UV REPLACEMENT AT HAVERSTRAW ELEMENTARY SCHOOL

MSA File No. 41048

NOTICE TO BIDDERS

Re: ADDENDUM NO. 3

Drawing Title
**3RD FLOOR
PLAN -
MECHANICAL**

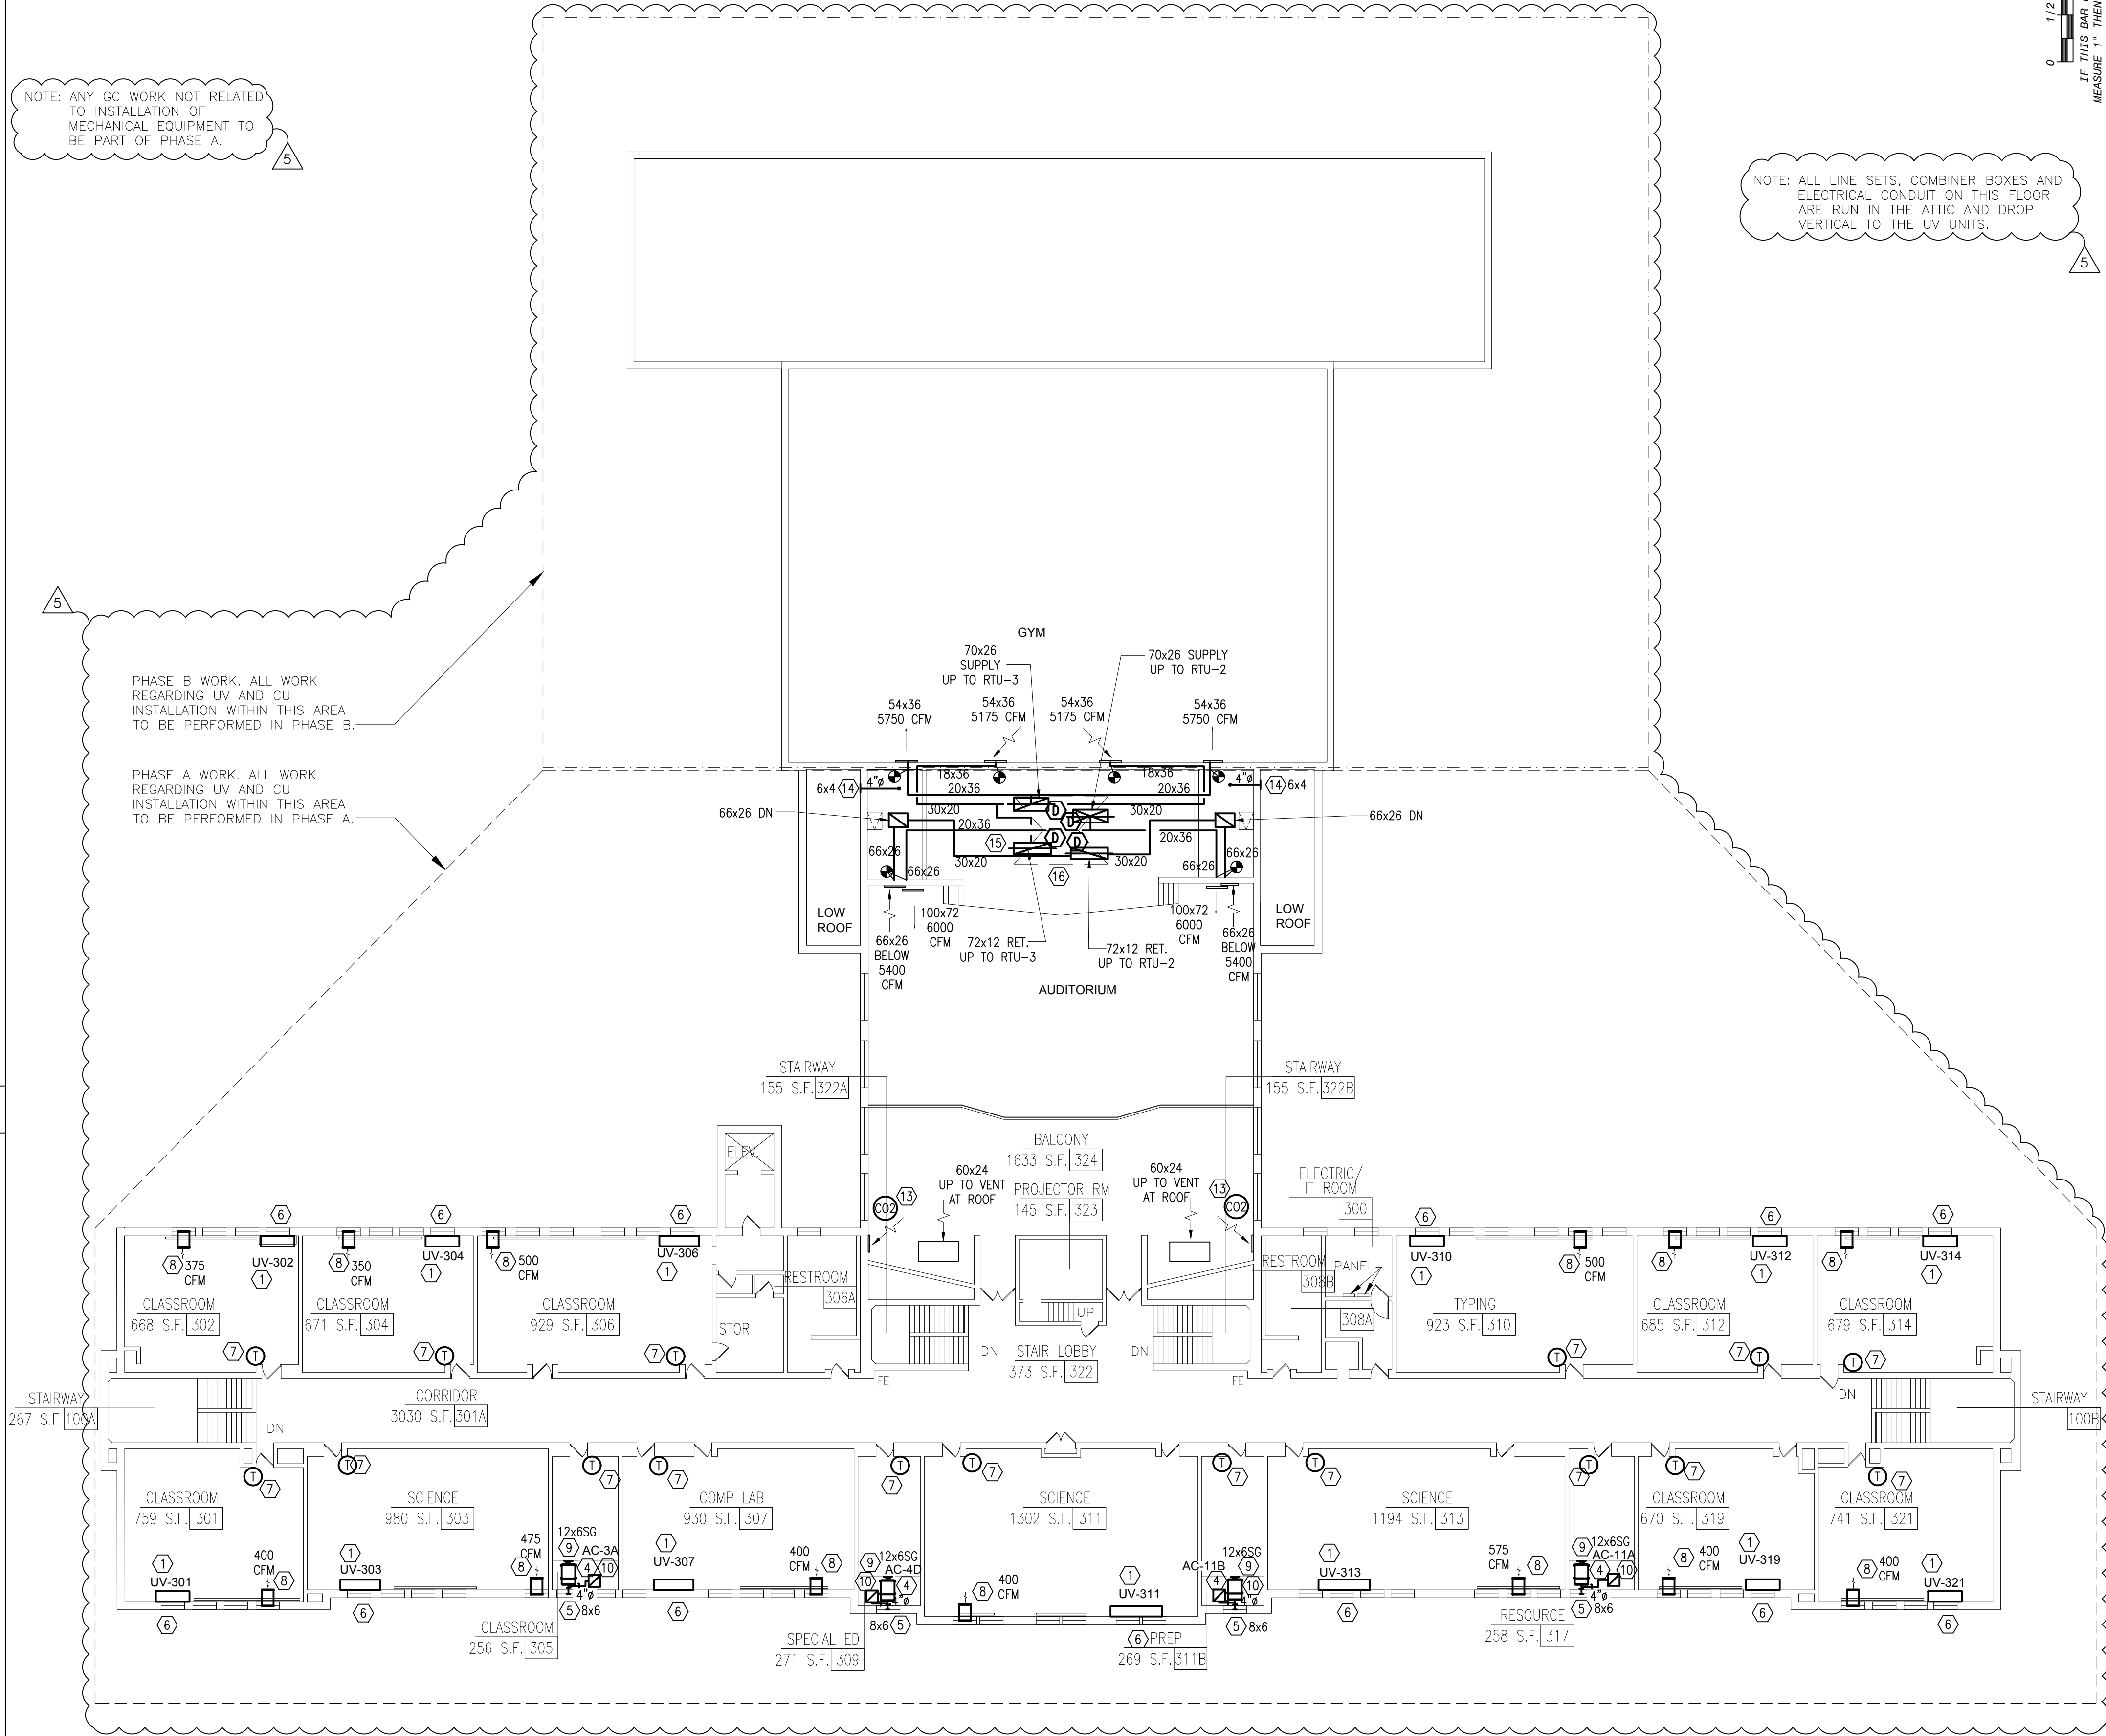
10. M-102- Added phasing and phasing notes, revised keynote #9 to indicate side grille type product, approved equal Titus 300/350 added.
11. M-103- Added phasing and phasing notes, revised keynote #9 to indicate side grille type product, approved equal Titus 300/350 added.
